# SERVICE BULLETIN SB0010

**SUBJECT:** Exhaust Shroud Clearance to Engine Frame

**MODELS AFFECTED:** CC18-180A SERIAL NUMBER 0001  
CC18-180 SERIAL NUMBERS 0002 THROUGH 0035

**FIGURE 1 –Left Side of Engine-Area in question at the mid-right side of photo, engine frame and exhaust shroud outlet**

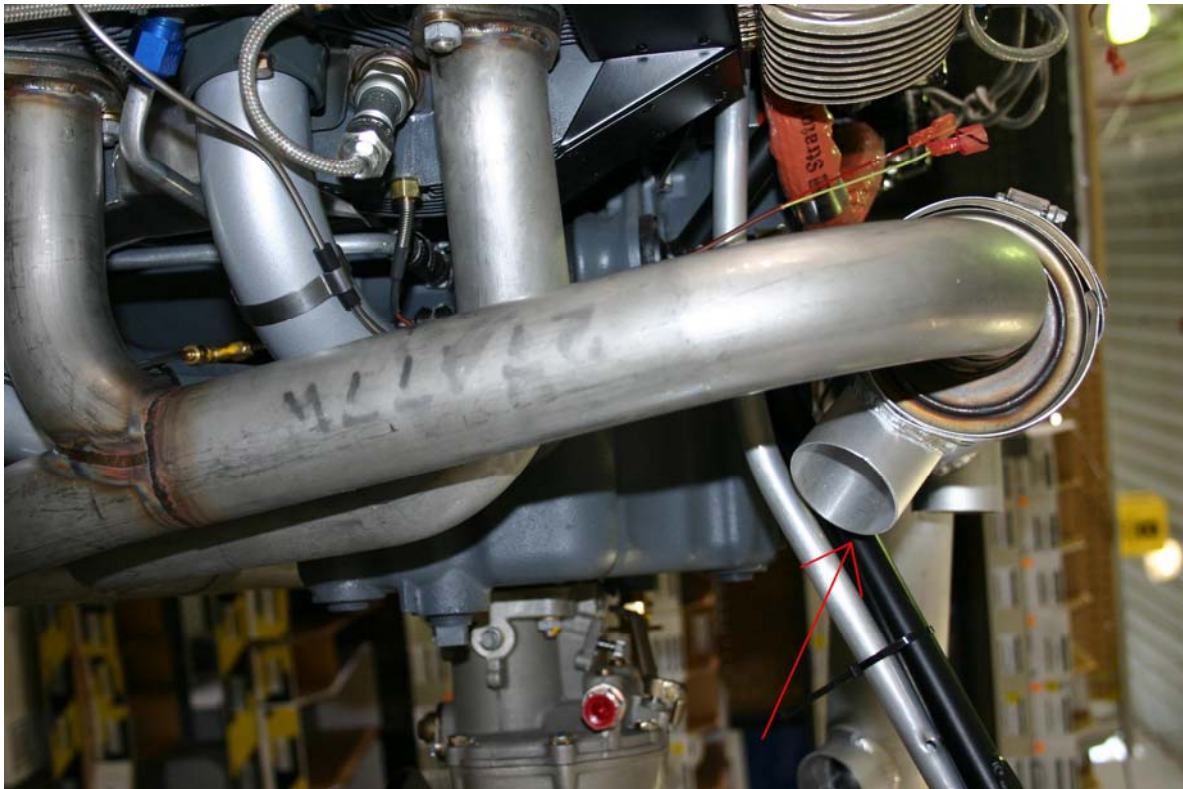
1. Open left side cowling and inspect the area near the cabin heat port on the exhaust shroud and the area of the engine frame for chaffing or damage. Removal of SCAT tubing and hose clamp may be required.
2. If no damage or problems are noted, there is no further action required. As described in the Aircraft Maintenance Manual TC10000AMM Section 05-20, normal inspections should always include inspection for any damage to the exhaust shroud, system, or engine frame.
3. If less than .25" clearance between the exhaust shroud and the engine mount tube is noted, determine if adjustment can be made to increase the clearance. If you are unable to get adequate clearance or the shroud is damaged and in need of replacement, contact Cub Crafters for a replacement that provides for additional clearance in the area. If damage is noted to the engine frame, contact Cub Crafters.

4. When reinstalling the heat shroud (as part of normal annual inspections, this heat shroud is to be removed and inspected as per the Aircraft Maintenance Manual TC10000AMM Section 05-20) care should be taken to locate the exhaust shroud in the proper left-right position and the proper rotational alignment to give as much clearance as possible with the cabin heat outlet and the engine frame. Slide the assembly left-right to center between the exhaust pipes, but also ensure the outlet has .25” or greater clearance to the engine tube.
